UNITED STATES
DEPARTMENT OF THE INTERIOR
BUREAU OF LAND MANAGEMENT
SUNDRY NOTICES AND REPORTS ON WELLS

5 Lease Serial No
NMNM-0121121
6. If Indian, Allottee or Tribe Name
7. Unit or CA Agreement Name and No
8 Well Name and No.
Cotton Draw Unit 110
9. API Well No.
30-015-36406
10. Field and Pool, or Exploratory
Paduca; Delaware
11. County or Parish State
Eddy NM

Devon Energy Production Co., LP
NM-0121121 – Cotton Draw Unit #110
API: 30-015-36406
Eddy County, New Mexico

RE: Flex Hose – Conditions of Approval

H&P 212, 214, 232, & 372 Location Dimensions

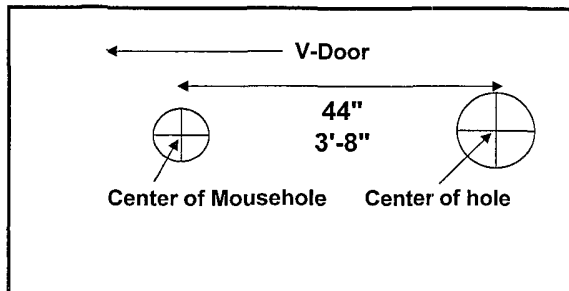
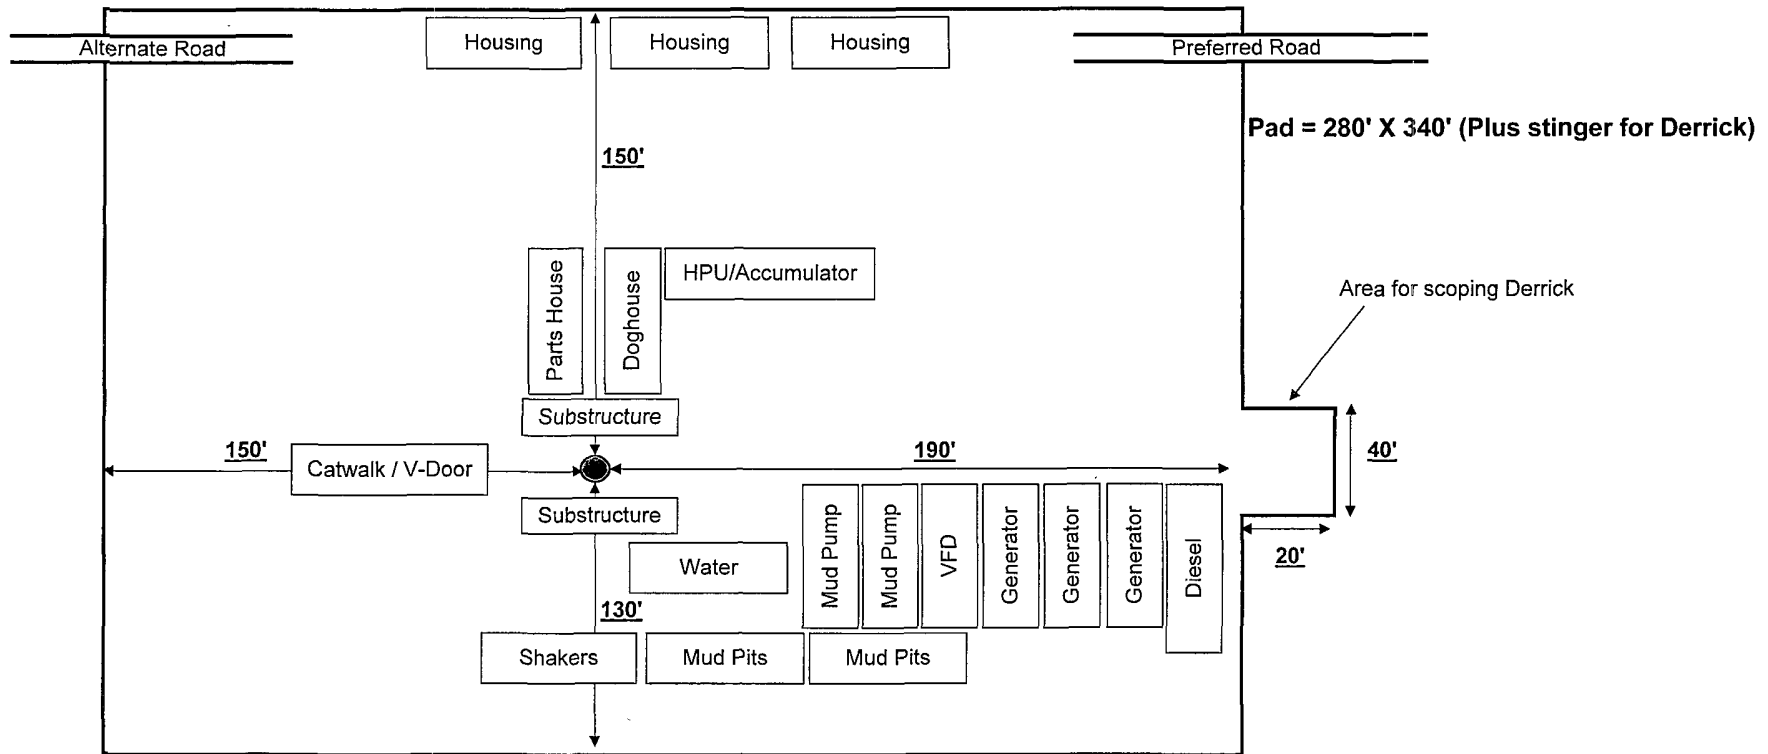
Devon Energy Production Company L. P. respectfully requests to change the rig layout from the Patterson 41 to the H & P #212 to drill this well and requests a variance that a co-flex hose may be used between the BOP and the choke manifold. The hose will be kept as straight as possible with minimal turns. CO-Flex Hose Manufacturer: Phoenix Beattie; ~33' (11.43 meters) of co-flex line; 3" coupling 2/ 4 1/16" flange on each end, 10,000 psi; Quality Control Inspection & Test Certificate attached; see configuraton schematic. Safety clamps are not required since the ends are flanged.

Variance approved to use flex line from BOP to choke manifold. Check condition of 3" flexible line from BOP to choke manifold, replace if exterior is damaged or if line fails test. Line to be as straight as possible with no hard bends.
